UNIVERSITY OF SOUTH CAROLINA

Amendment NO.3

SUBJECT: USC-IFB-3521-DG/Provide all personnel, materials and installation necessary to perform water damage repairs at University of South Carolina Beaufort Campus.

DATE: August 22, 2019

RECEPTION/SECURITY 107 ELEVATION

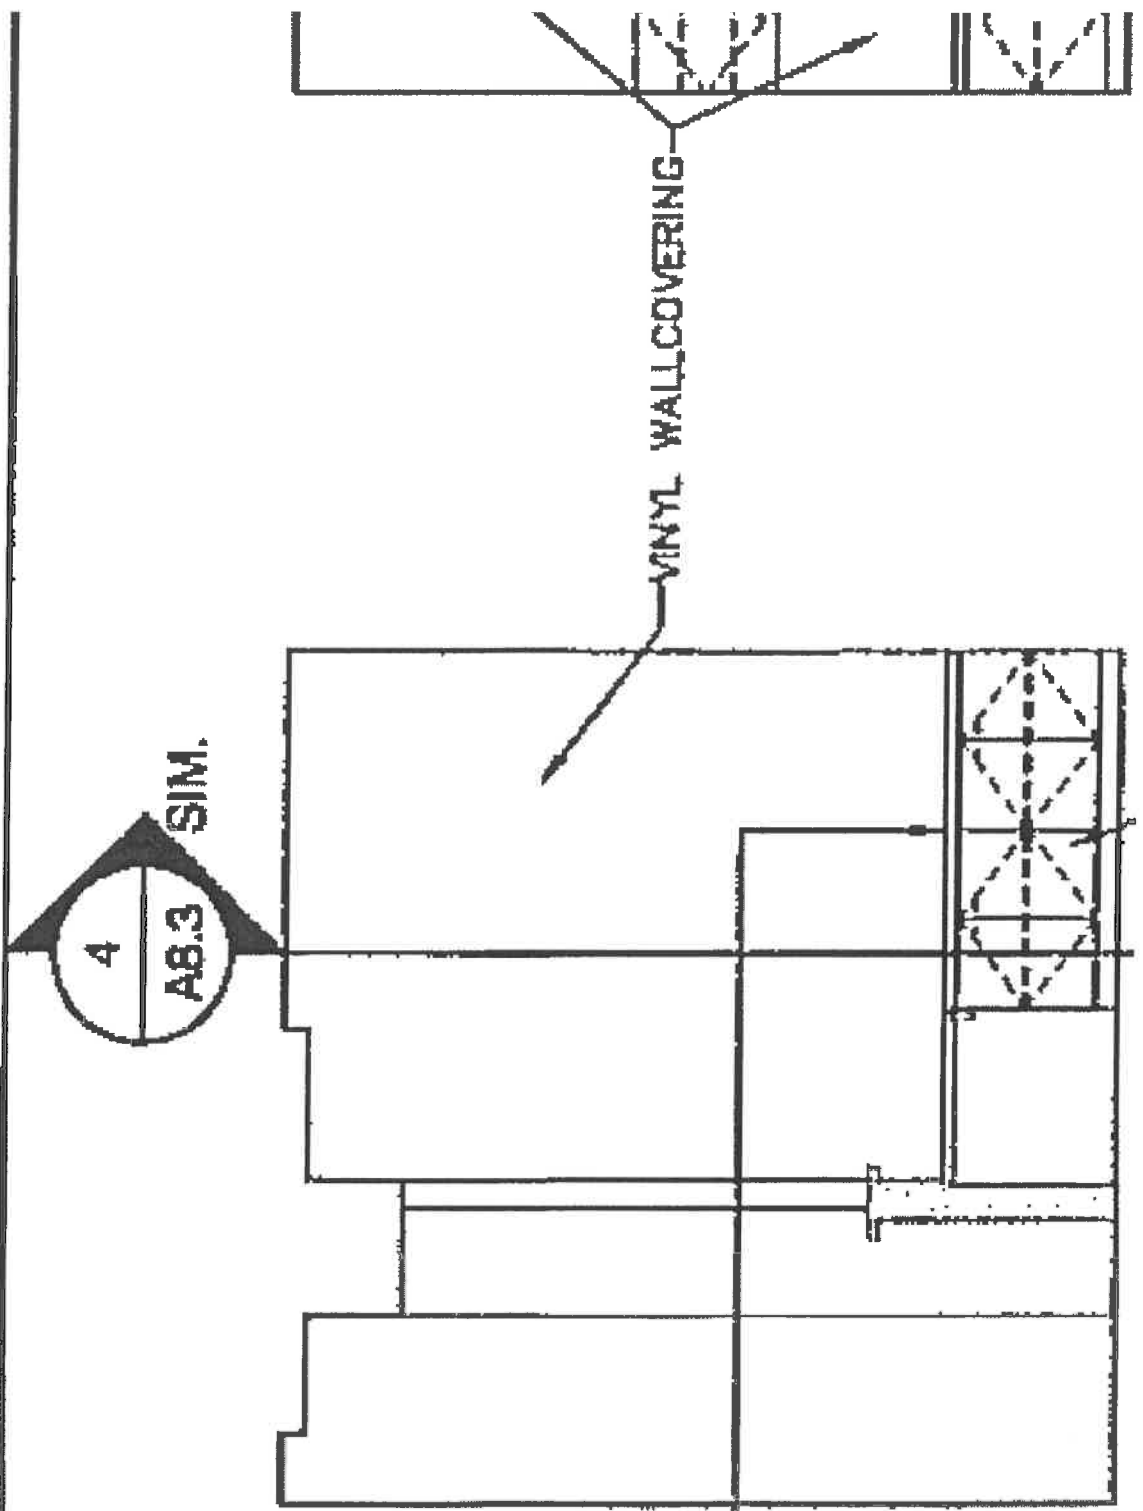
- 1) Wallpaper in Hargray reception 107 (Area 1) – we cannot match the wallpaper. A paint as close to the wallpaper color is acceptable since it is not immediately visible from the front desk. Paint can be to the line of damaged wallpaper on the back right area of the wall.
- 2) The cabinetry behind the Hargray reception 107 (Area 1) desk should match existing paneling and front desk. There is an elevation of the cabinetry. Detailed drawings attached.
- 3) The molding by the Science & Technology Area # 6 – Entrance Vestibule Right Side that is missing is not available for re-install. It needs to be completely replaced.
- 4) We do not have attic stock carpet on Area # 3, Hargray H213 or Area # 7, Science & Technology seating area. Since it is not abutting any other carpet we are fine with picking something as close as possible.
